DVE 8031/8032
TECHNICAL SERVICE BULLETIN #1

Product: DVE 8031 / 8032

Re: Installation of G15381- Conversion Kit DVE 803x

Diagram for reference only

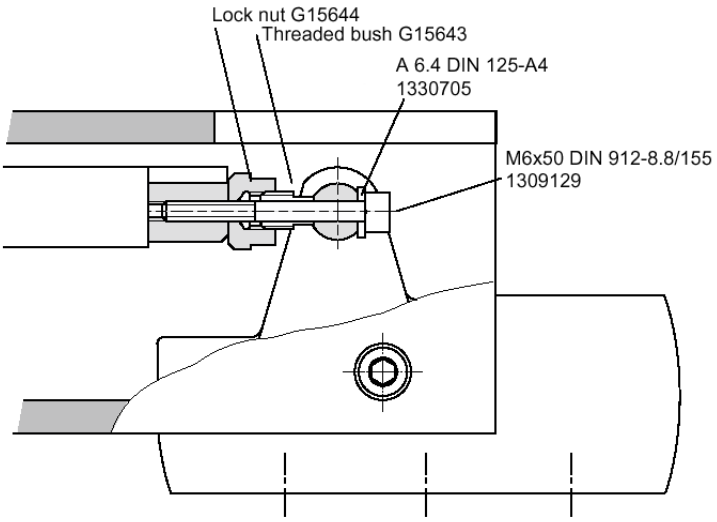
Reason/Rational: Draeger Medical has released a hardware modification to increase the vertical stability of the pendant head or pendant column.

Devices affected: Ceiling Supply Units DVE 8031/ 8032 up to serial number ARND-0235 (prior to May 1999), **without** combination of adjusting nut G15644 and threaded bushing / nut assembly G15643.

Solution/Procedure: Install part number G15381- "Conversion Kit DVE 803x". Refer to Service Procedure SP00239. See "Additional Info", below.
